The heritage properties and houses located at the lowest point of Middle Harbour Rd will be blocked directly sunlight from the north ,east ,west all day by the proposed develop large building (over 30 meters high and over 100 meters wide) located at the north highest point. The reasons why I strongly oppose this development plan are as follows:

## 1. Non-Compliant Shadow Impacts

**Source Document:** Clause 4.6 (Appendix P )Report Fig.6 (Solar Study)

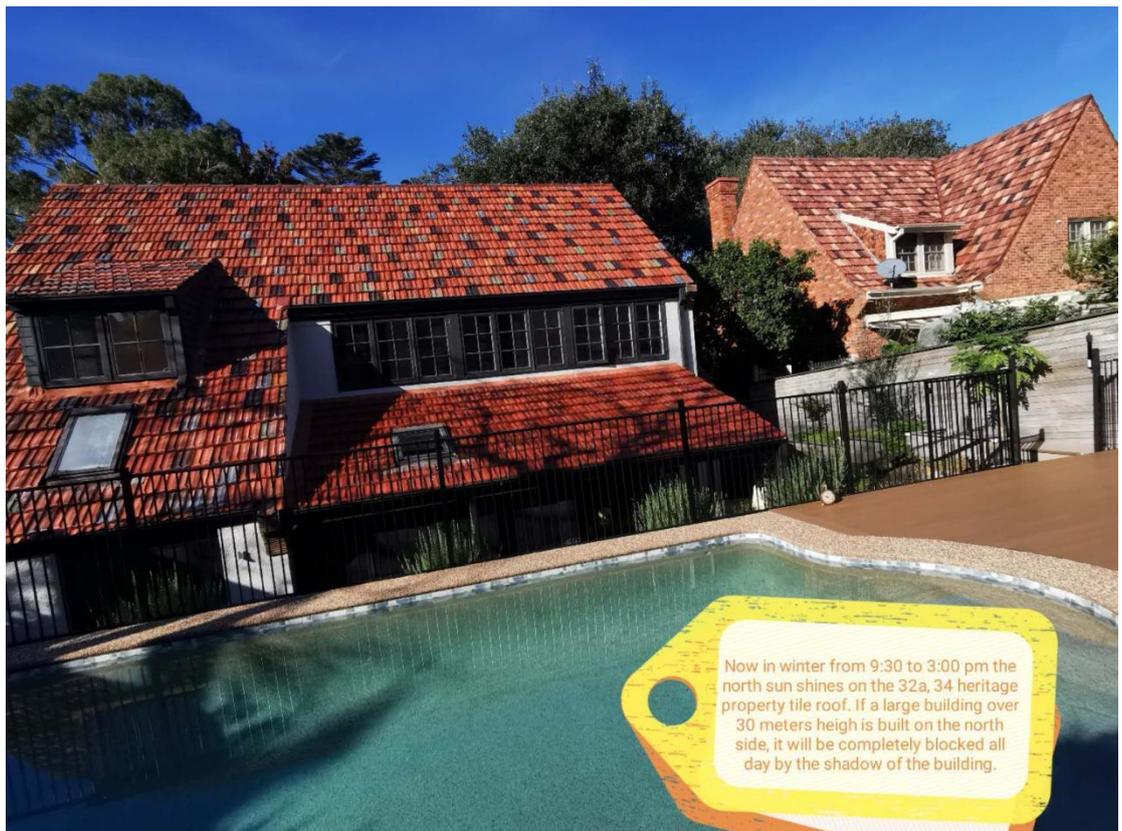
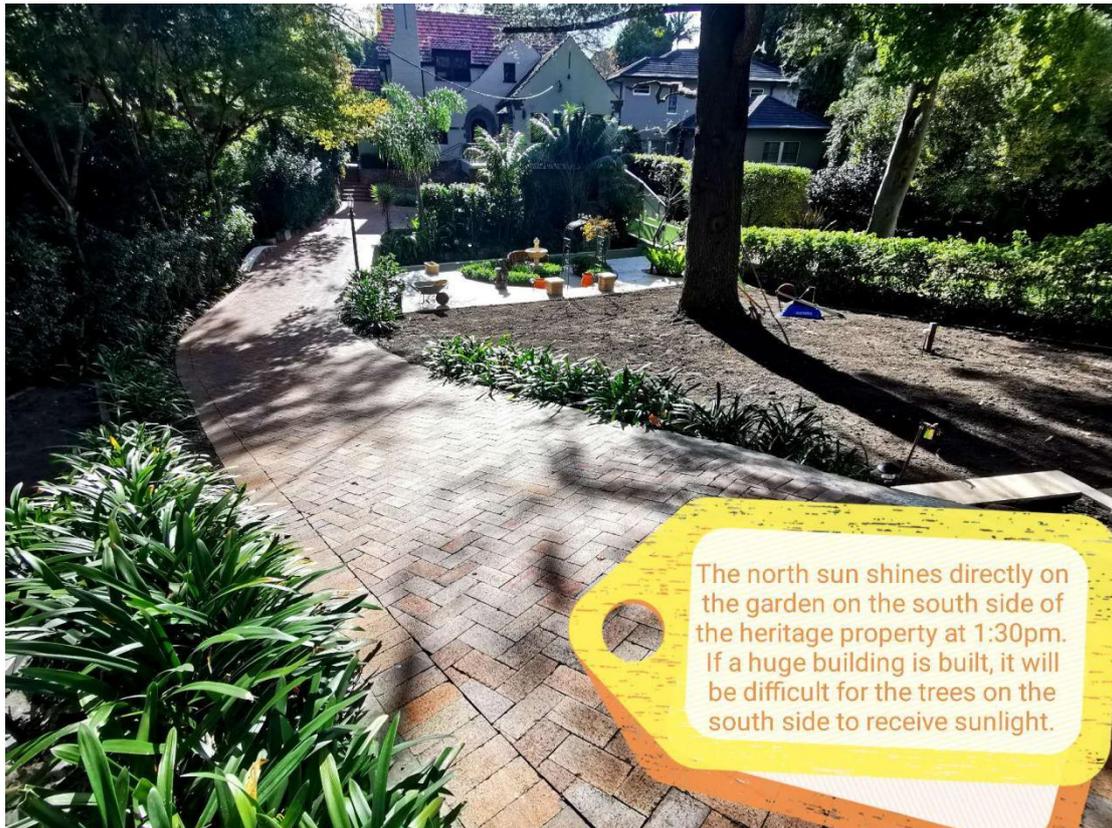
- a) Analysis only covers June 21 (day before winter solstice), ignoring year-worst scenario (June 22 solar altitude 0.5° lower).
- b) Simply mentioning that sunlight reaches the house, deliberately avoiding the regulatory requirement of “direct sunlight between 9am and 3pm on 21st June is to be maintained to the living rooms, primary private open spaces and any communal open spaces”

Recalculation using developer’ s data: Direct sunlight at 34 living rooms drops from 6 hours to less than 1 hour in winter. The main north-facing living space of 55 Trafalgar Ave,30,32,32A Middle Harbour Rd completely loses direct sunlight from 9 am.

- i )SEPP (Sustainable Buildings) 2022 Clause 4.3 (3-hour minimum).
- ii )Ku-ring-gai Development Control Plan ( Hereinafter referred to as“KDCP”) 7A.2 Site Layout [ Controls ] 10 ( 3-hours minimum).

## 19D.2 SETBACKS AND BUILDING SEPARATION

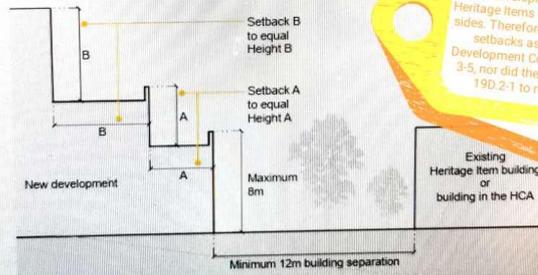
The development project is adjacent to Heritage items on the north, east and south sides. Therefore, they did not make greater setbacks as required by Ku-ming gai Development Control Plan 2024 Figure 7A 3-5, nor did they follow the provisions of 19D.2-1 to make further setbacks.

Figure 7A.3-5: On steep sites adjoining lower density zones, setbacks may need to be more generous.

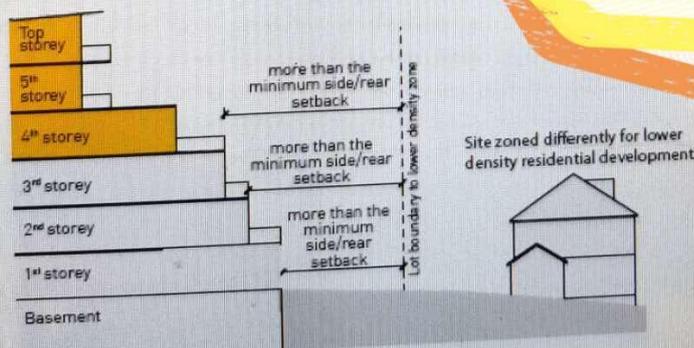
According to the regulations here, the developer's design is completely inconsistent with the regulations. All our heritage properties are downhill, and the development buildings should be set back a certain distance on each floor.

**Source Document:** HIS(Appendix J) & Clause 4.6 (Appendix P) Report Fig.4

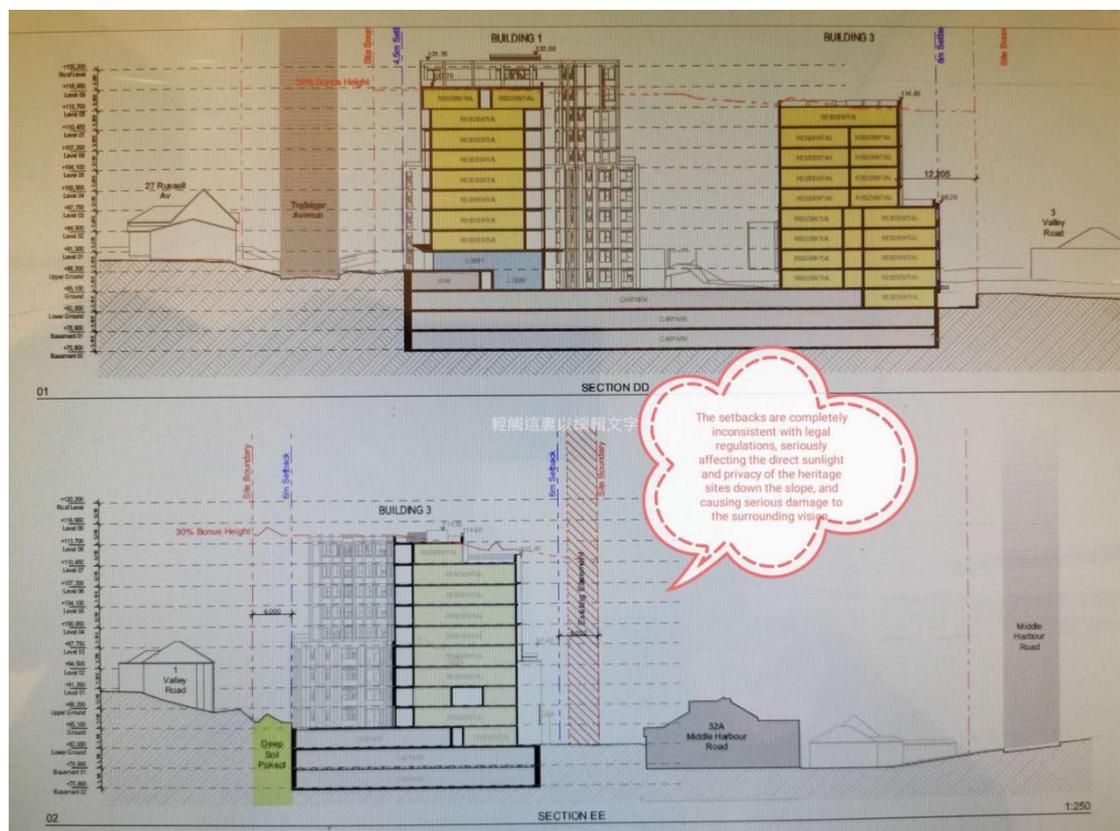
The entire text of HIS (Appendix J) contains no statement at all about the impact of reducing the impact on Heritage Items 32A (1453) & 34 (1452) Middle Harbor Rd. In fact, the negative impact of the proposed development on the above two Heritage Items is devastating in all aspects. The proposed development deliberately avoids this major impact issue.

- i ) KLEP 2015 s5.10(4): "Must consider effect on heritage significance."
- ii ) Australia ICOMOS Burra Charter 2013 Principle 6: New development must not dominate heritage setting.
- iii ) "KDCP" 19F.1 LOCAL CHARACTER AND STREETScape [Controls 4"Views"]
- iv ) "KDCP" 19A.2 Subdivision And Site Consolidation Of a Heritage Item [Objectives 5]
